1. Agency Jurisdiction:

2. Background:

3. Observations and Recommendations:

Figure III-1: Volume Balance between PS6 and PS7 uncorrected for long-term average.

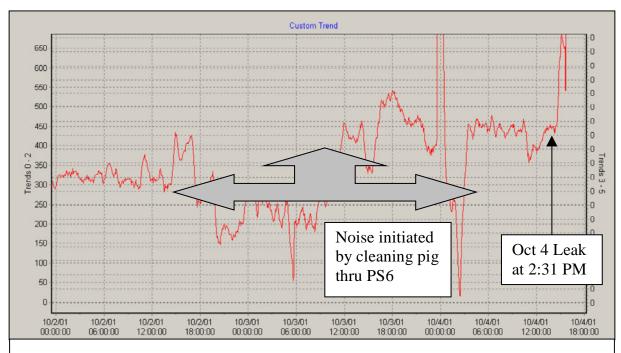
- (1) None of the APSC Leak Detection Systems alarmed, before the leak was discovered visually, as a result of the bullet hole leak of October 4, 2001. The current leak detection sensitivities are well within the 1% of throughput and is known BAT, per State regulatory requirements.
- (2) The TVB Leak Detection System did detect a volume imbalance between Pump Station 6 and Pump Station 7; however, the imbalance did not meet other necessary validation conditions for an audible leak alarm to be sounded to the pipeline controllers at the Valdez Terminal. The TVB was operating normally, however flow measurement shifts after the passage of a cleaning pig through Pump Station 6 reduced the TVB's effective sensitivity.

Recommendation: Continue on-going efforts to improve current systems.
